Project	IEEE 802.16 Broadband Wireless Access Working Group < http://ieee802.org/16 >	
Title	2-antenna MIMO pilot allocation for PUSC/FUSC	
Date Submitted	2005-01-13	
Source:	Jianglei Ma, Peiyong Zhu, Wen Tong, Ming Jia, Mo-Han Fong, Hang Zhang, Brian Johnson Nortel Networks 3500 Carling Avenue Ottawa, ON. K2H 8E9 CANADA	Voice: (613)-765-8089 Fax: (613)-765-7723 pyzhu@nortelnetworks.com
Re:	Call for Reply Comments regarding the Maintenance Task Group Comment Report 80216maint-04_09.zip	
Abstract	In this contribution, we propose to clarify the 2-antenna MIMO pilot allocation for PUSC/FUSC	
Purpose	The contribution should be considered by Maintenance group within comment resolution procedure	
Notice	This document has been prepared to assist IEEE 802.16. It is offered as a basis for discussion and is not binding on the contributing individual(s) or organization(s). The material in this document is subject to change in form and content after further study. The contributor(s) reserve(s) the right to add, amend or withdraw material contained herein.

2-antenna MIMO pilot allocation for PUSC/FUSC

Figure 245 – Cluster structure

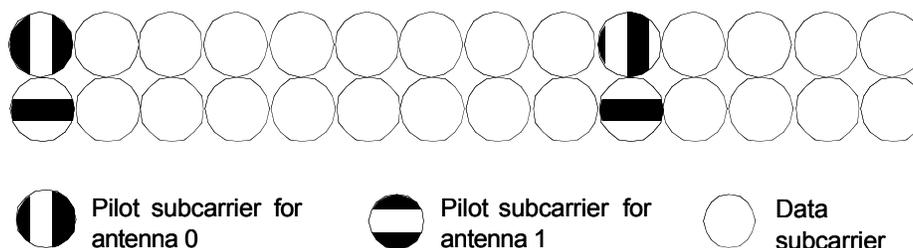
The clusters composing the subchannels used by the STC mode shall be allocated and subcarriers numbered as defined in 8.4.6.2. The cluster structure of the subchannels allocated for STC is slightly modified to fit the STC requirements. The structure shall be modified as depicted in Figure 245 (switching 2 pilot carriers from ~~the odd symbol~~ with 2 data carriers ~~from the even symbols separately~~, switching of the data carriers and the pilots carriers shall be performed after constellation mapping, therefore maintaining all the encoding scheme and the subchannel allocation scheme). In this scheme, transmission on regular subchannels and STC subchannels is possible and is determined by the MAC layer (the allocation is performed by allocating major groups of subchannels for regular or STC transmission). The transmission of the data shall be performed in pairs of symbols as illustrated in Figure 246 ~~247~~.

Insert the following section after Figure 245:

The pilot locations in PUSC cluster shall obey the following rule:

$PilotsLocation = (PUSC_PairNumber) \bmod(2) * 4 + PUSC_Pilot_Location$
 where $PUSC_PairNumber$ is the OFDM symbol pair index in each PUSC allocation and counts from 0 to 1.
 $PUSC_Pilot_Location = 0, 8$ is the frequency offset of the pilot carriers in each cluster.

Figure 246—STC usage with PUSC

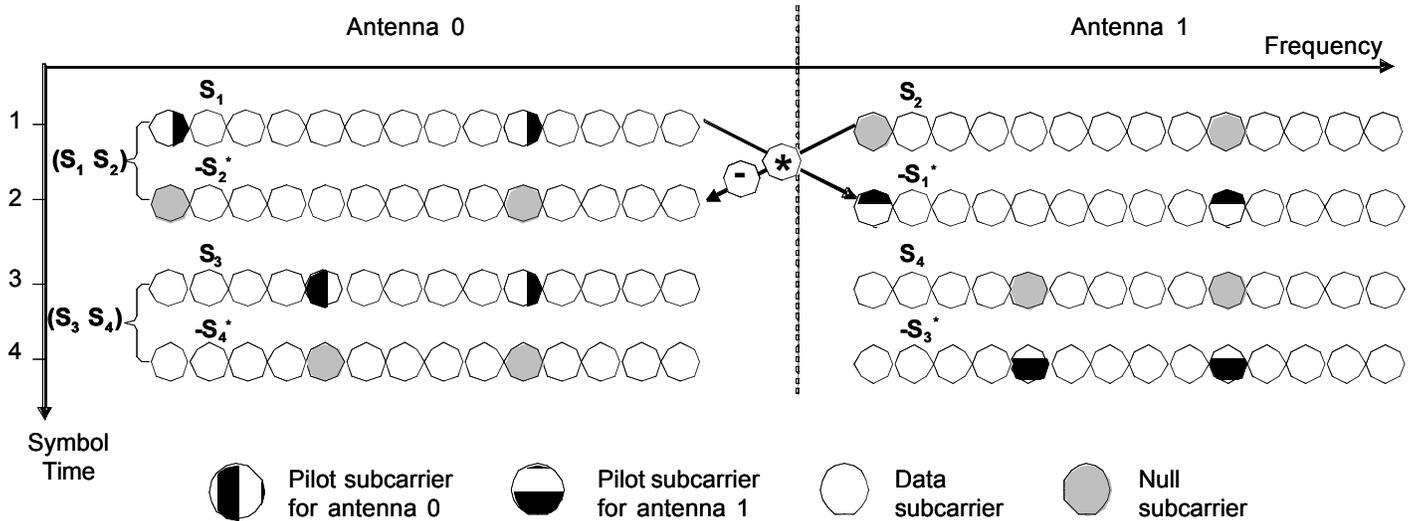
Delete Figure 246, Figure 247 can be used for both PUSC and FUSC.
 Modify Figure 247 caption Figure 247-- STC usage ~~with FUSC~~

Replace Figure 246
